SUBJECT: AMENDMENT NO.142 TO FACILITY OPERATING LICENSE NO. DPR-43 -
KEWAUNEE NUCLEAR POWER PLANT (TAC NO. MA1557)

AMENDMENT TO FACILITY OPERATING LICENSE

Amendment No. 142
License No. DPR-43

ATTACHMENT TO LICENSE AMENDMENT NO. 142

FIGURE TS 2.1-1

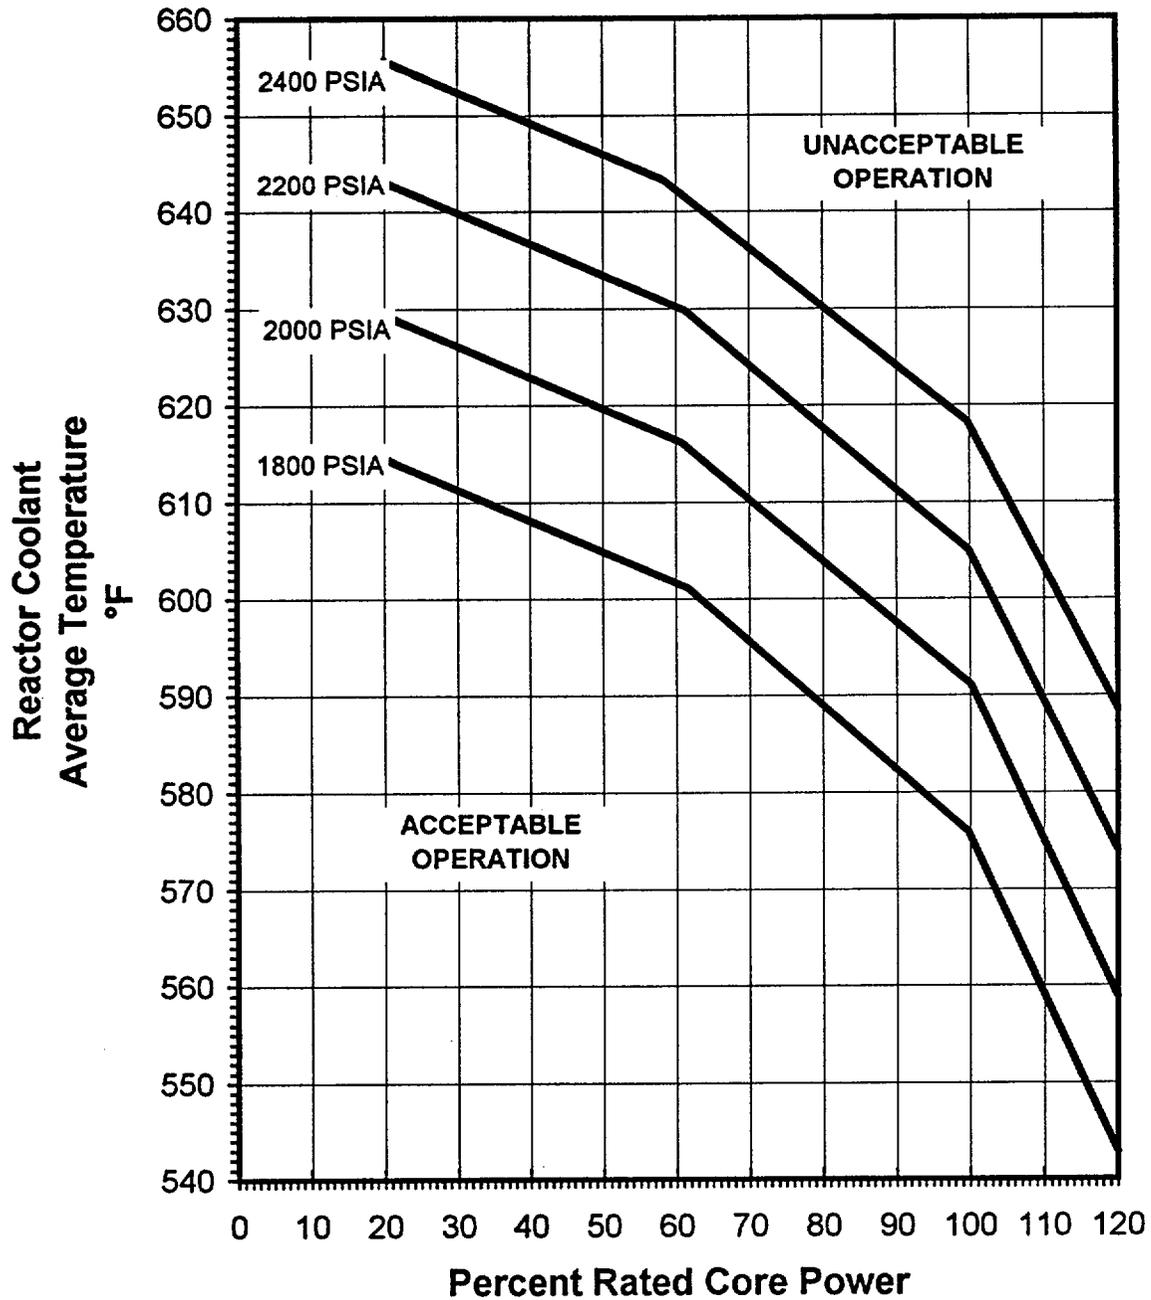
1) Figure 2.1-1 and TS B2.1 - Core Safety Limits

The core safety limits (maximum core powers as functions of the RCS pressure and temperature) are revised to reflect the use of the HTP correlation and its associated DNBR safety limit, RCS flow, peaking factors and fuel design. Since the core safety limits are calculated based on the approved methods for licensing applications and the acceptable results of the transient and accident analyses, the staff concludes that the revised safety limits are acceptable.

FIGURE TS 3.10-1

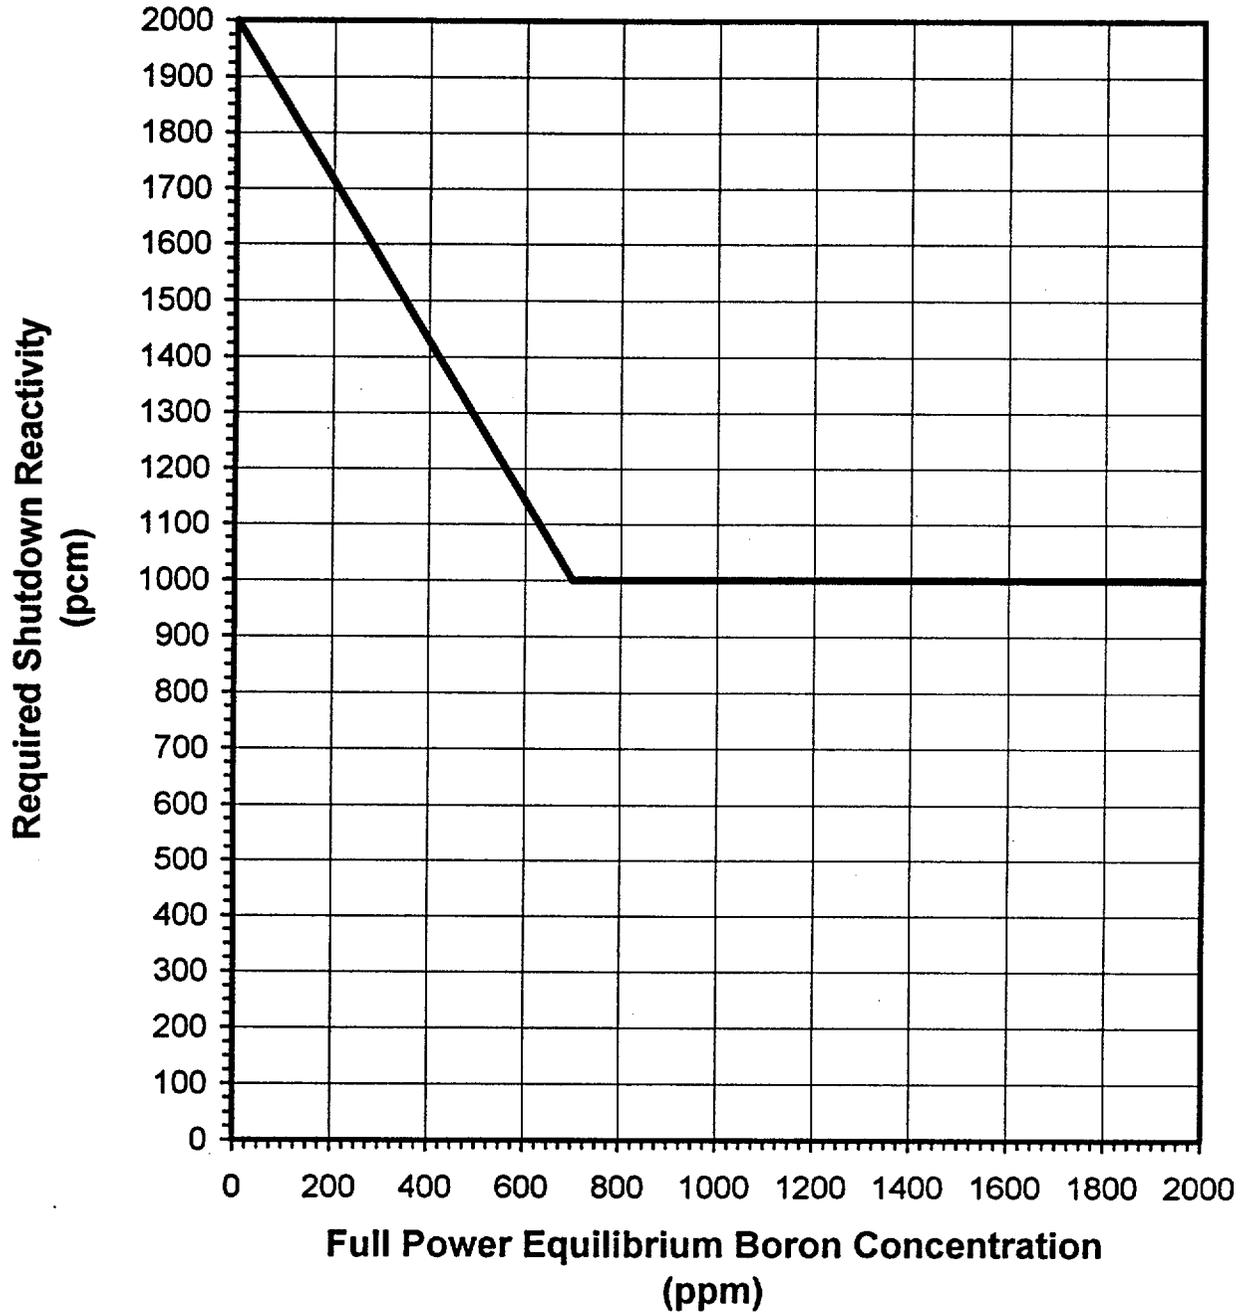
7) Figure 3.10-1 - Required Shutdown Reactivity Vs. Reactor Boron Concentration

This figure represents a relationship between the required shutdown reactivity reactor boron concentration. The limits for the shutdown are not changed. The required shutdown reactivity line is extended from 1300 ppm to 2000 ppm to account for the 18-month fuel cycle. The existing values are not changed in the safety analysis or in the TS. Therefore, the proposed TS is acceptable.

FIGURE TS 3.10-2

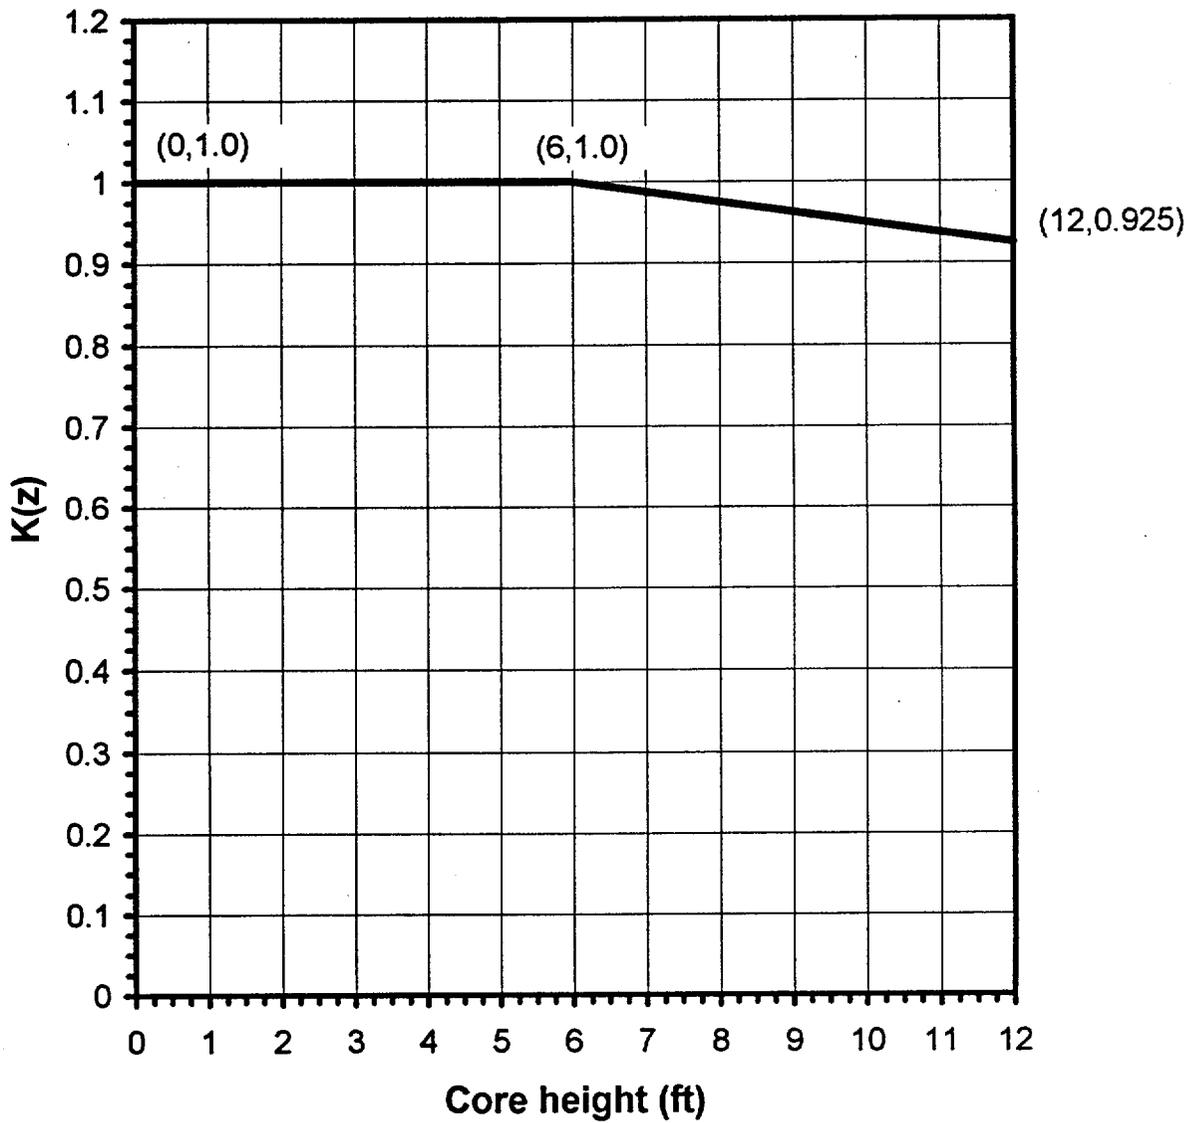
8) Figure TS 3.10-2 - Hot Channel Factor Normalized Operating Envelope

This figure represents the hot channel factor normalized operating envelope. It is revised to reflected the values used in the acceptable safety analyses and is, therefore, acceptable.
